HISTORIC PRESERVATION COMMISSION STAFF REPORT

Address: 8813, 8815 & 8817 Hawkins Lane Meeting Date: 2/22/95

Resource: Hawkins Lane Historic District HAWP: Alterations

Case Number: 35/54-94A and 94B Tax Credit: No
REVISION/RETROACTIVE

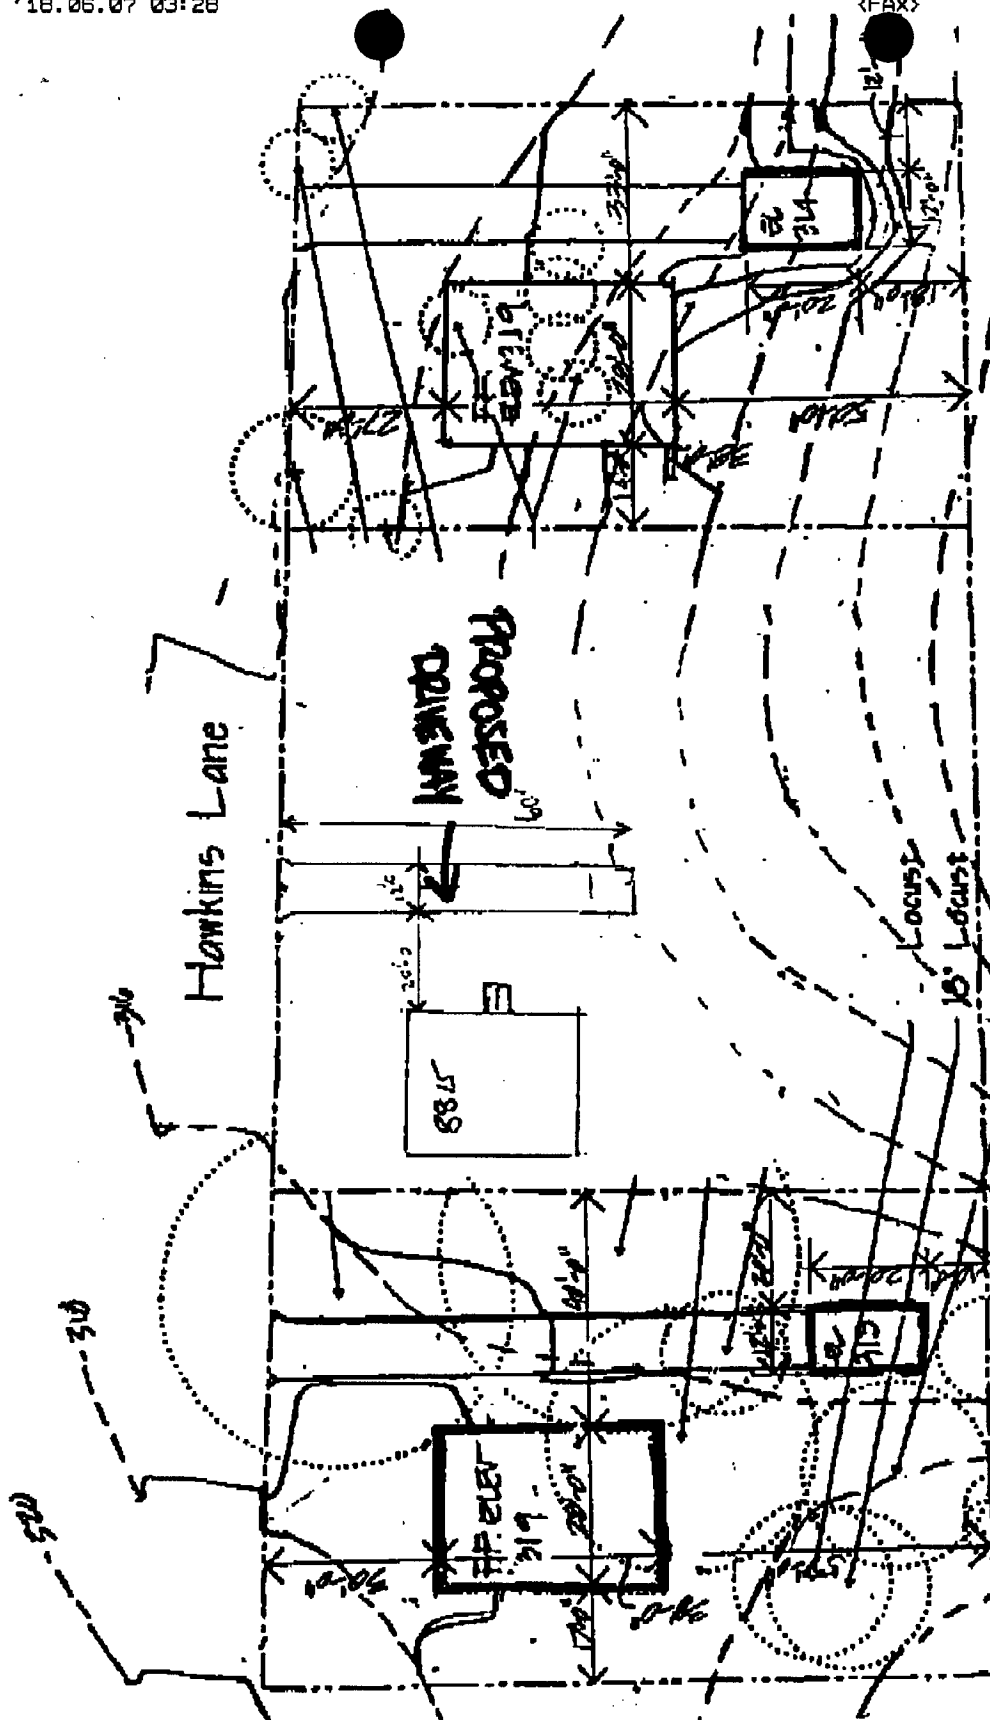
Here is the driveway layout for 8815.
These are the exact dimensions drawn to
scale. I hope this is what you
are looking for. I will call you
today. Thanks

- Within an approximate 10' X 10' region in this corner are:
- 5' Mulberry
 - 8' Locust
 - 15' Locust
 - 23' Ash, hollow

Plan of 2/1994

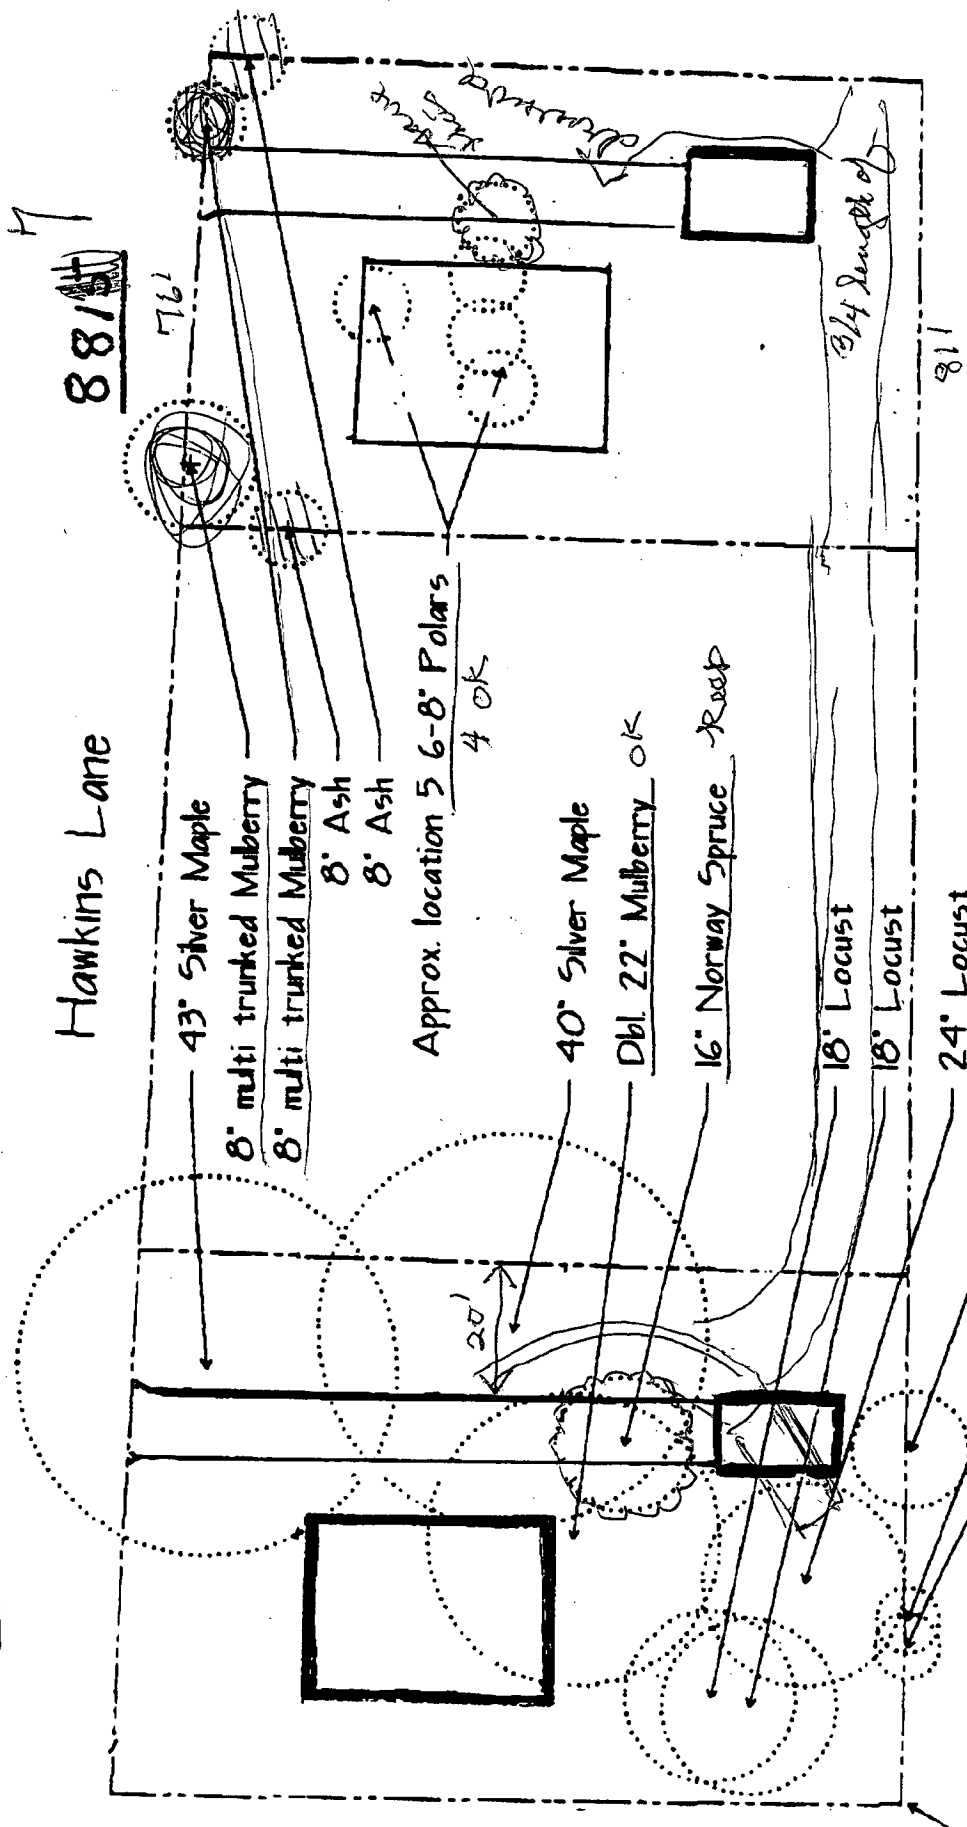
Testifying at the session on February 22nd regarding Walter Hsu's application for a new driveway for 8815 Hawkins Lane almost seems futile since the driveway was roughed out and has been in use for months. It amazes me how Walter's drawings for proposed work are so much less detailed than those for work that has been finished. Note that the "plan" that accompanies the application for 8815's driveway shows the completed houses at 8813 and 8817 with the distance between the houses and their lot lines; you can infer from the plans for these completed houses that the driveways which are shown for the two (only one of which has been built) will be about 8' feet north of each house and 10' wide. Why isn't there comparable detail for the proposed 8815 driveway?

On the basis of my experience with Walter's building practices which deviate from his words, the lack of detail in his plans allows him great latitude to do whatever he pleases. The plans submitted to the Commission for the two new houses last year also lacked detail about the specific location of the houses and their driveways on their lots. (I have a copy of them with me if anyone wants to compare the plans.) The driveway for 8817 cannot be built as shown because the multi-trunked mulberry is only 12' from the tree. The current driveway drawing for 8817, while it has more detail than his old application, is still misleading. The 8" ash, which is outside my fenced yard, is shown on the property line. Walter's survey before he began construction told him that our common property line is about 4' north of my front yard's side fence, i.e., several feet inside my fenced yard, a fact which I do not dispute.

I think that before this retroactive application for a driveway permit is granted, Walter Hsu should provide more detail about his driveway: how far north of his house, how wide and how deep will it be. I think this is especially important given the remarks of his realtor: that 8815 will be demolished and a larger house built in its place. Where will such a house go in relation to the driveway which is the subject of this application? I also think that Walter's enormous pile of brush and stumps that have been a haven for rodents for over a year should be removed and the lane restored to its former state before any other action is permitted. Actions need to occur before any more words are approved.

8815

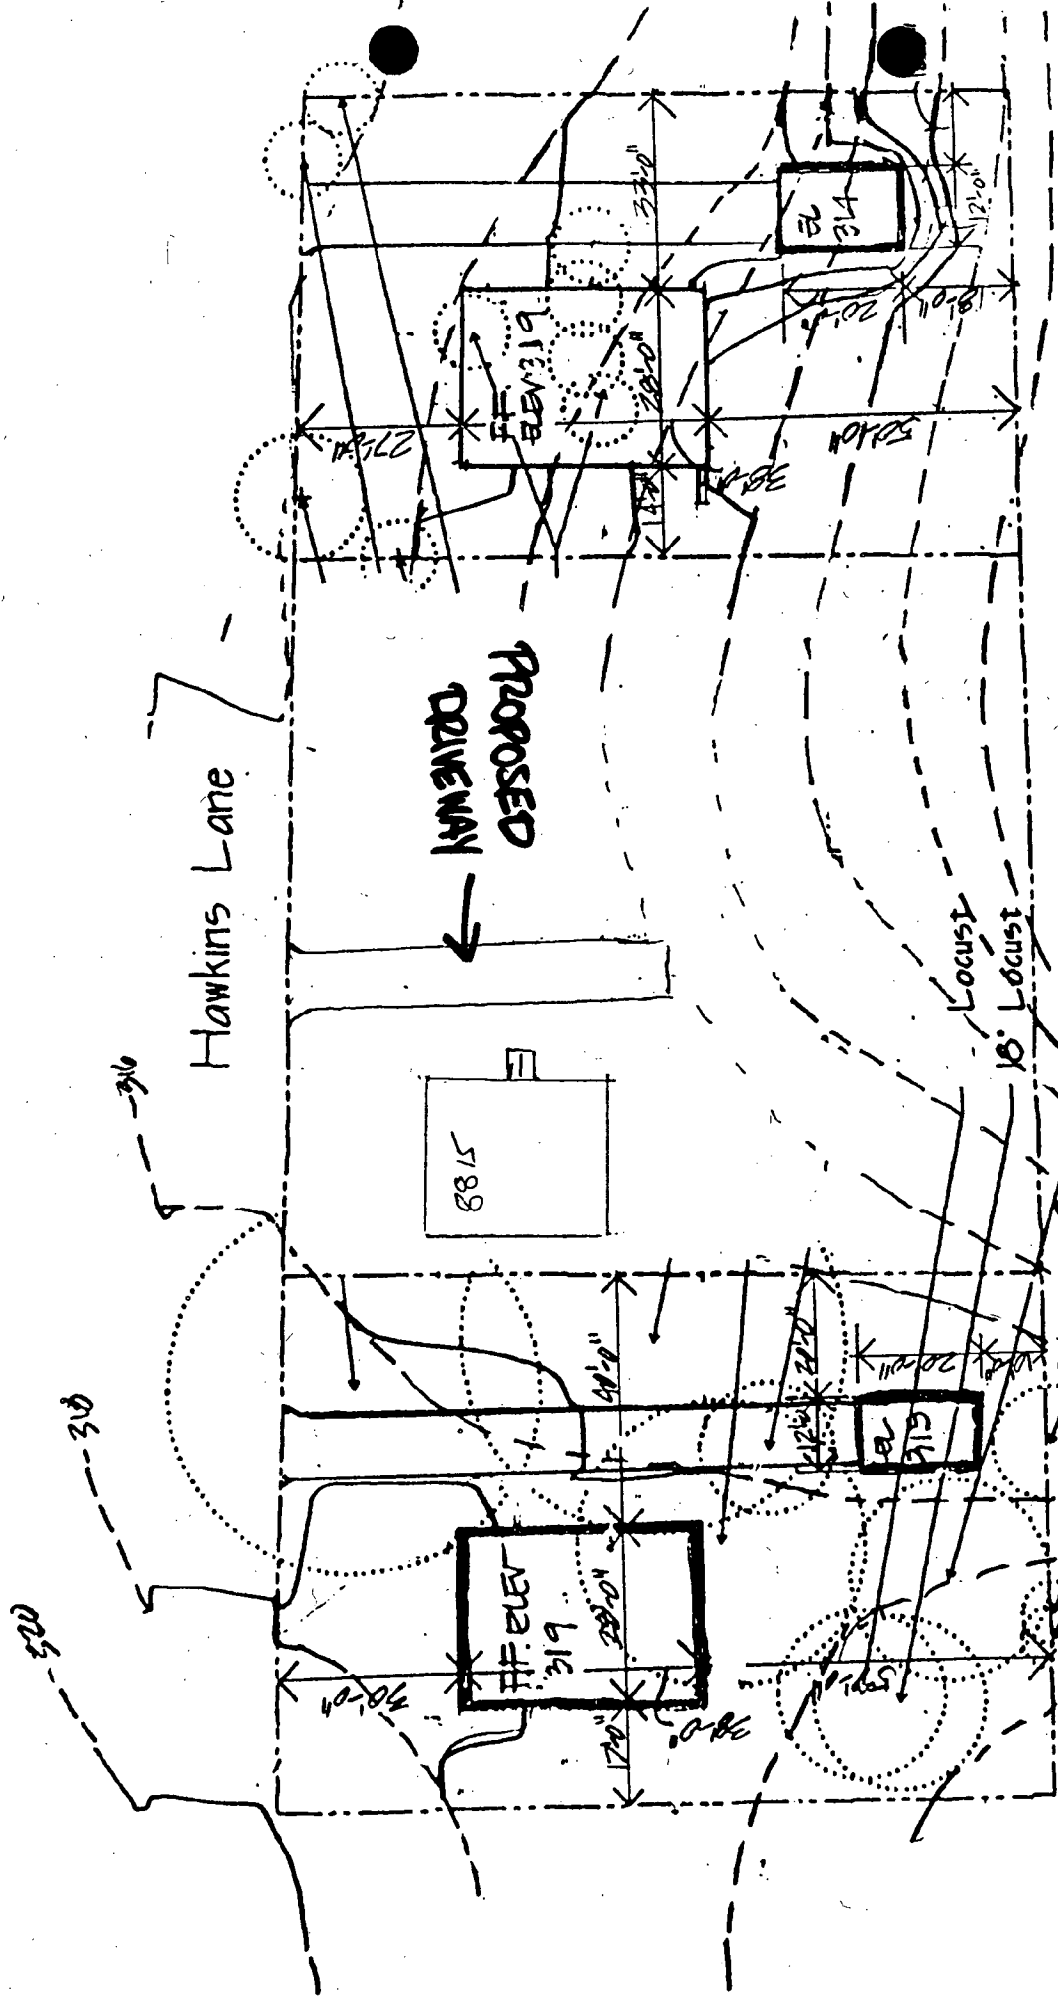
- Locust
- 18' Locust
- 24' Locust
- 12' Mulberry
- 6' Mulberry
- 7' Locust

Within an approximate 10' X 10' region in this corner are:
 5' Mulberry
 8' Locust
 15' Locust
 23' Ash, hollow.
